Office Action Summary	Application No. JK 10/762,890	Applicant(s) CONTE, ROBERT	
	Examiner Biju Chandran	Art Unit 2835

DETAILED ACTION

FIG. 11

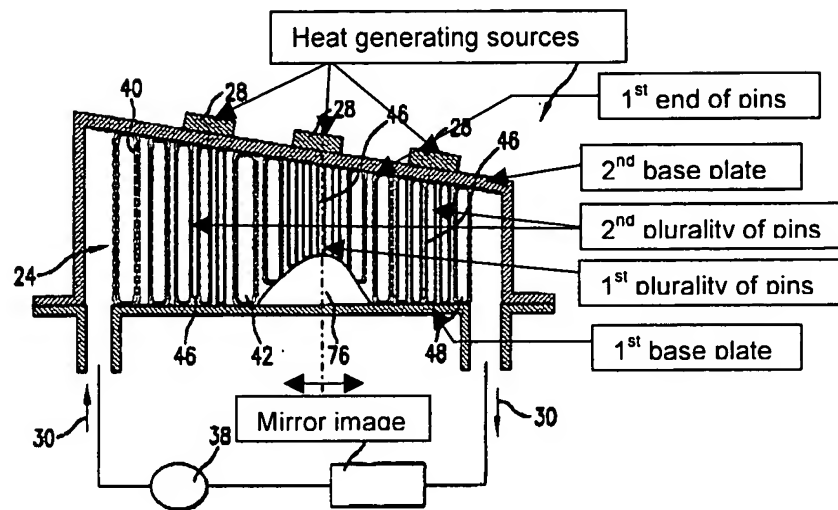
- Regarding claim 11, Dessiatoun et al. further discloses that the second end of each pin of said first plurality of pins is positioned in said coolant channel for transferring heat from said heat generating source to said cooling medium (see figures 2, 11, 13-16, and 18).

- Regarding claim 15, Dessiatoun et al. further discloses a second base plate and a second plurality of thermally conductive pins located in said second base plate for transferring heat from another heat generating source to said cooling medium, said second plurality of pins extending substantially perpendicular to said second base plate, a first end of each of said second plurality of pins being in contact with said another generating source, said second base plate located substantially parallel and opposite said first base plate, such that said first and second plurality of pins are mirror images of each other being positioned in said coolant channel (marked in figure).

- Regarding claim 16, Dessiatoun et al. further discloses that a pin in the first plurality of pins is offset from corresponding pin in the second plurality of pins (see attached figure), such that a wave type of passage is created for the cooling medium (column 11, lines 5-25).

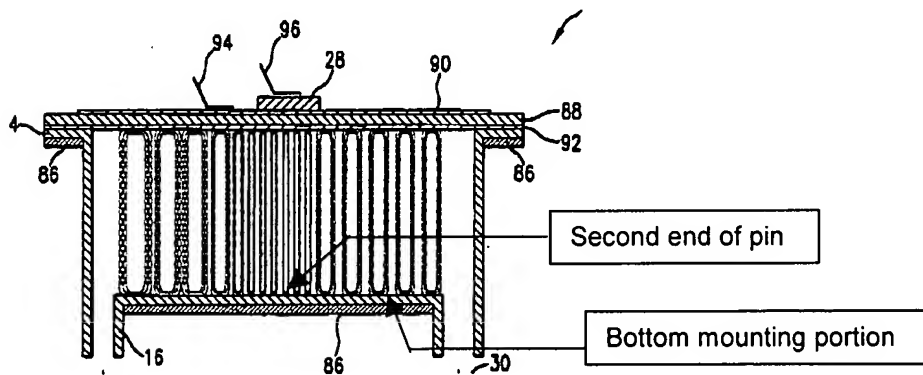
- Regarding claim 14, Dessiatoun et al. further discloses that a surface on said second end of each pin of said first plurality of pins, substantially perpendicular to a longitudinal direction of said first plurality of pins, slightly contacts said bottom mounting portion during the expansion of said first plurality of pins due to a heat transfer process (see attached figure).
